## ***Interactive comment on “Simulation of storm surge inundation under different typhoon intensity scenarios: Case study of Pingyang County, China” by Xianwu Shi et al.***

Received and published: 19 June 2020

**Fig. 1.** The relation between the central pressure difference ( $\Delta P$ ) and the radius of maximum wind ( $R_{max}$ )

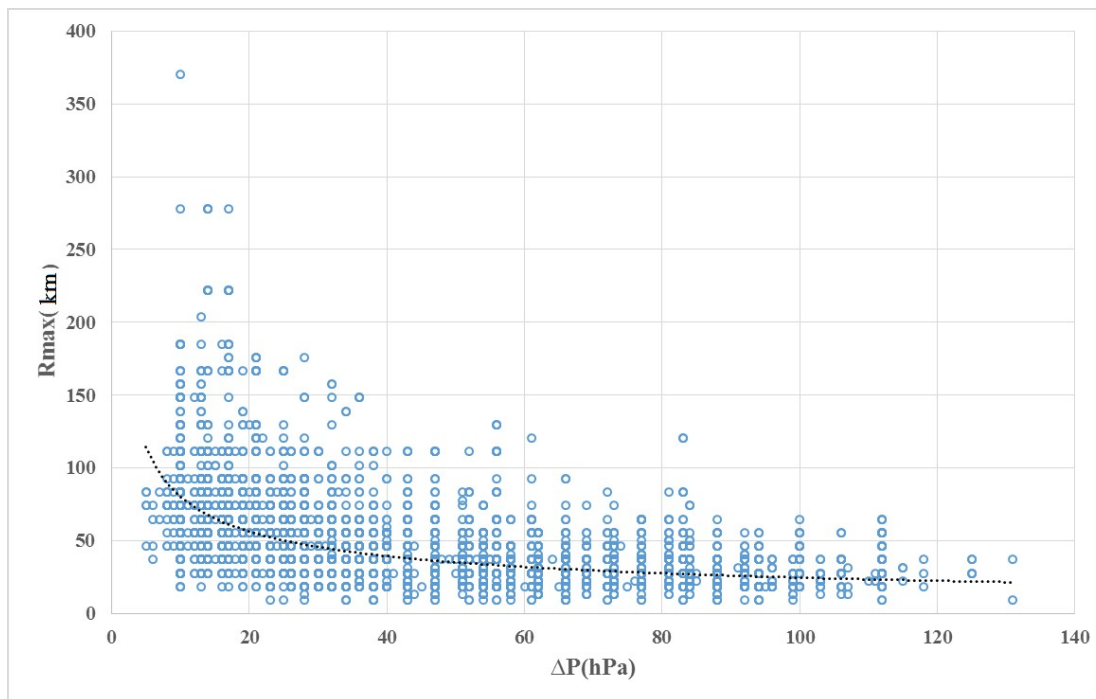
3. Additionally, the typhoon size is inversely proportional to the typhoon intensity if the Jelesnianski typhoon model was used. This phenomenon should be discussed in the manuscript. Response: Thanks for your suggestion. The typhoon size has a strong connection to the typhoon intensity. As described above, radius of maximum wind speed was used to indicate the “size” of the typhoon. Collecting the historical radius of maximum wind speed data measured in the northwest Pacific hurricane records (2001-2016) from the Joint Typhoon Warning Center (Wang et al, 2020), it can be seen that the radius of maximum wind speed is inversely proportional to the central pressure difference. In this study, the empirical relationship below was used to calculate the value of  $R_{max}$ :  $R=R_0 - 0.4(P_0 - 900) + 0.01(P_0 - 900)^2$  where  $P_0$  is the central air pressure (hPa),  $R$  is the radius of maximum wind speed, and  $R_0$  is an empirical constant. Therecor
